TECHNICAL NOTE

2020s0819
Walmersley Old Road, Bury
Barratt Homes
September 2021 [Rev 4]
M Hemsworth
R Thrower
Geomorphology Appraisal

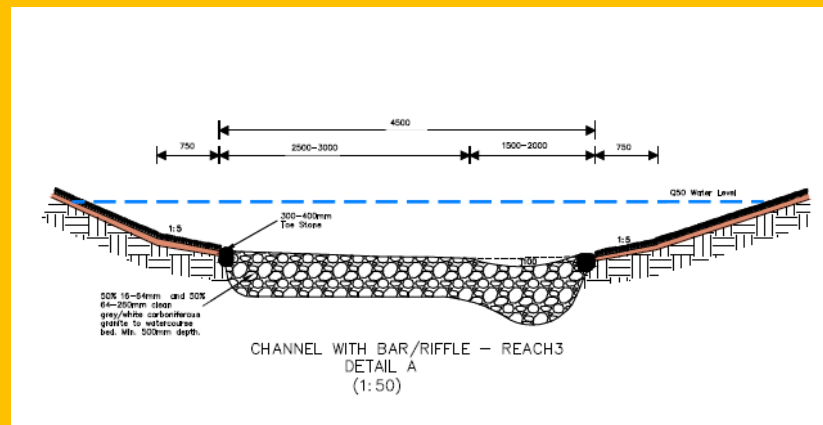
July 2021	A further review was undertaken to assess the potential buffer to allow for local change within the pool and riffle section of the proposed channel. The following extract from the design indicates that the channel width at

the base of the slope is typically ~4.5m wide, with a low flow notch indicated in the design. It is hope this will allow for localised adjustments to be made. This should be clearly defined in a monitoring and management plan to ensure natural adjustment is allowed to take place.

Action: Amend plans to identify areas within the channel where natural adjustment is acceptable and provide a link on the drawings to the monitoring and management plan.

The following documents have been used:
6155-516(B) Flood Storage Area General Arrangement.pdf
6155-507-02(D) Proposed Cross-sections.pdf

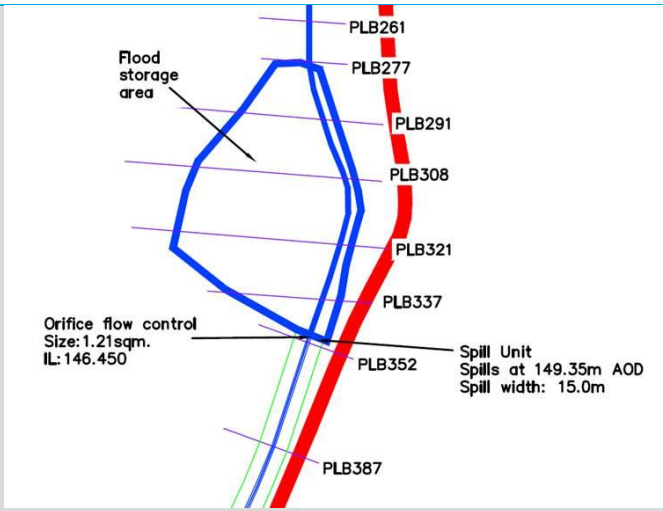
Initial Geomorphology Observation	• Velocities in the storage area range between 0.081 - 0.4m/s in all events between 2-yr flood event and the 1000-yr flood event. • 0.08m/s: This indicates sand will be transported but larger sediment will not be transported or entrained. • 0.4m/s: This indicates sand and some small gravels will be entrained and transported but larger sediment will not be mobilised. • Analysis of velocity alone does have limitations - since erosion is driven more by near bed shear stress than velocity. • The results indicate the storage area will be a depositional zone, assuming sediment is transported into the reach from upstream. However, the results are coarse is resolution and do not represent the detailed functioning of the storage area (i.e. local flow dynamics aren't represented - a more detailed 2D modelling approach would typically be preferred).	
May 2021 Design Appraisal	Consultation may be required with the Environment Agency regarding sediment depletion and future maintenance and management requirements. A more detailed representation in a hydraulic model of the storage area would allow local flow dynamics to be assessed and options could be tested - i.e. installation of a low flow channel through the storage area etc, which may have greater benefits in terms of river system functioning. Action: Further hydraulic modelling required

July 2021 Design Appraisal	A review of modelling undertaken by CEC indicates that whilst a low flow channel has been maintained through the storage area, sediment deposition is still likely to occur. This will need long term management via a management and monitoring plan. Action: Management and monitoring plan to be developed

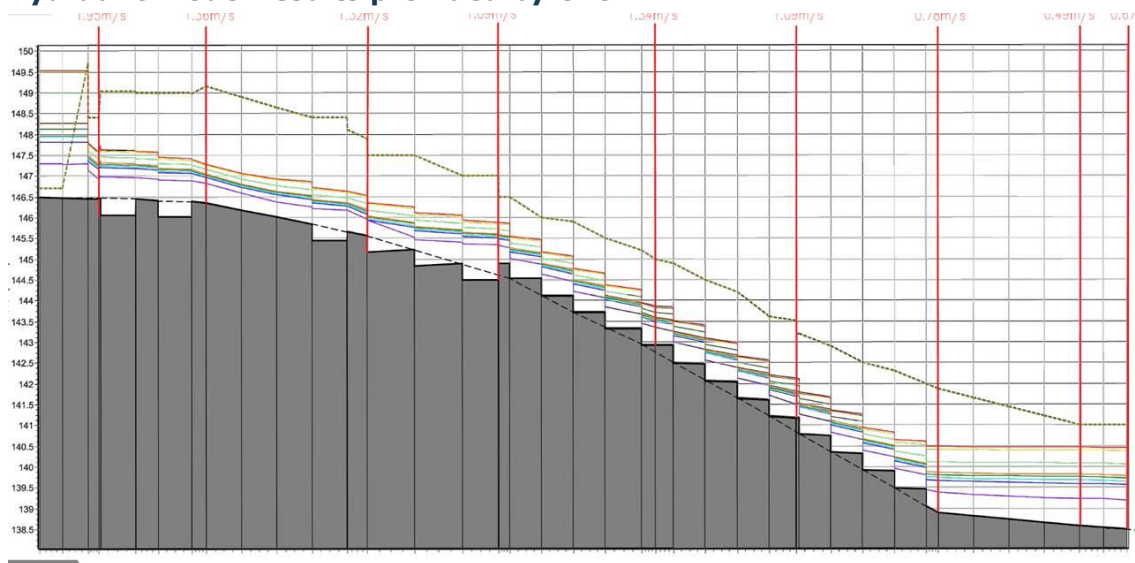
This assumes sediment is sized to allow for it to be keyed into the bed adequately – assuming 200-300mm bed embedment. It is noted following discussions with CEC that the side slopes limit a varied spacing between step pools – where possible, some differentiation in spacing would be preferable, however, if the spacing is uniform it is anticipated that there will be little impact on morphological processes. Action: update plans to identify where (if possible) step pool spacing can be varied (even if only slightly).	Stone	400mm Step	Central key stone	600mm to 700mm	Step boulders	500mm-600	Step particles	400mm-500mm	Pool cobble grade	100 – 150mm	Bank toe stone	300 – 400mm	Bank edge gravels (in front of bank toe stones)	20 – 100mm
Stone	400mm Step														
Central key stone	600mm to 700mm														
Step boulders	500mm-600														
Step particles	400mm-500mm														
Pool cobble grade	100 – 150mm														
Bank toe stone	300 – 400mm														
Bank edge gravels (in front of bank toe stones)	20 – 100mm
